SPECIALIST COMMENTS RESPONSE – SUNFIELD DEVELOPMENTS LIMITED RESPONSE TO AUCKLAND COUNCILS MEMORANDUM

Further to your recent instructions, we have reviewed Auckland Council comments dated 16 June 2025 and have responded to the transport matters raised.

**Cosgrave Road / Walters Road /
Hamlin Road (Road 6)**

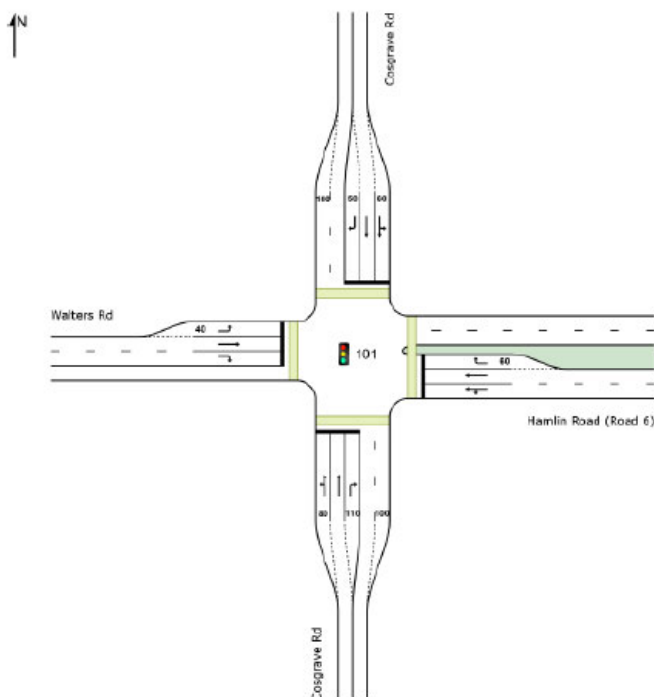
- e) Confirm if the provision of car share parking spaces (ratio of 1:11.5) has been accounted for in the trip generation rates assumed.*
- f) The Cosgrave Rd/ Walters Rd/ Hamlin Rd intersection appears incorrect in terms of the land configuration. Confirm if the layout of this intersection as used in the transport model is correct.*

We are unsure of the exact question / comment. However, the Cosgrave Road/ Walters Road/ Hamlin Road intersection has been modelled as per Table 9-2 of the ITA (shown below)
